MONTGOMERY COUNTY HISTORIC PRESERVATION COMMISSION
STAFF REPORT

Address:	10203 Meredith Ave., Silver Spring	Meeting Date:	5/23/18
Resource:	Contributing Resource Capitol View Historic District	Report Date:	5/16/18
Review:	HAWP	Public Notice:	5/11/18
Case Number:	37/07-18C	Tax Credit:	Partial
Applicant:	Carrie & Tom Witkop	Staff:	Dan Bruechert
Proposal:	Window Alteration, Replacement, and other Alterations

Figure 1: Front (south) elevation of 10203 Meredith Ave.

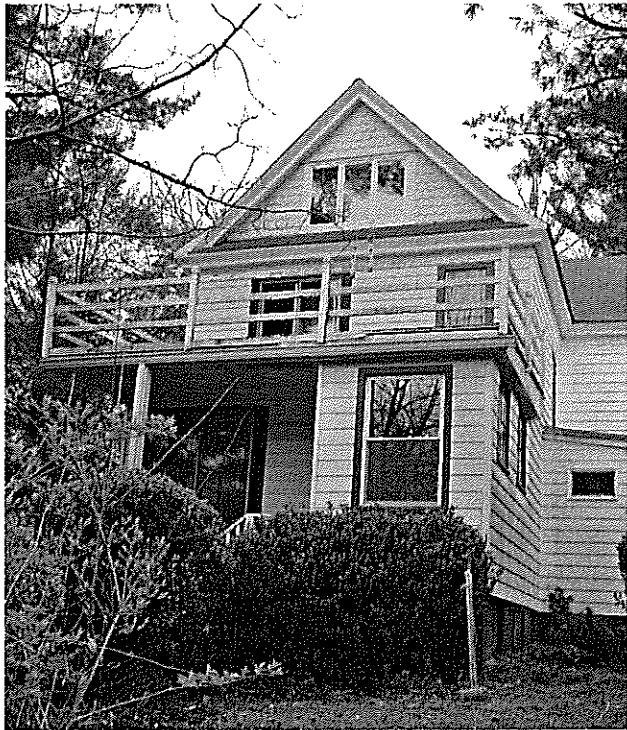
The subject property is a two-story house with a cross gable roof and several modifications. The front of the house is orientated to the south toward the intersection of Meredith and Pine Streets. Staff believes that 10203 Meredith and 10201 Pine St. were constructed of matching designs, though 10201 Pine St. retains more of its integrity. The house had wood clapboard siding with shingle decorations in the gables, though the siding is now covered by aluminum siding. The historic wood windows have virtually all been replaced with vinyl windows; only two historic windows remain (a sash window on the east elevation with stained glass and an arched casement window in the attic also on the east elevation). The front porch has been partially enclosed and modified (as shown in Figs. 1 and 2). The rear of the house has a kitchen addition and enclosed

Figure 3: Accessory Structure in rear of the subject property (construction date unknown).

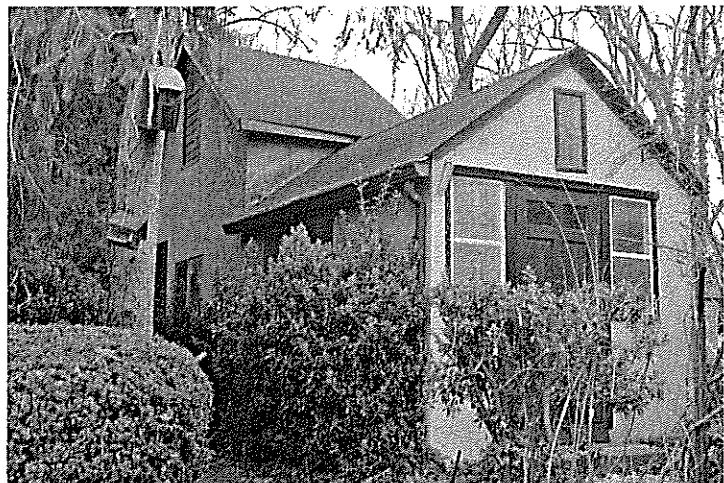
There is a small stucco accessory dwelling on the property to the north as shown in Figure 3. The front room is covered by a front gable roof and has a front door flanked by two windows. To the rear there is a taller side gable section with a ground floor door, pair of casement windows with a vent in the gable. The date of this structure is unknown; however, it is not shown on the 1931 Montgomery County Atlas when Meredith Ave. was still named Walnut Ave.
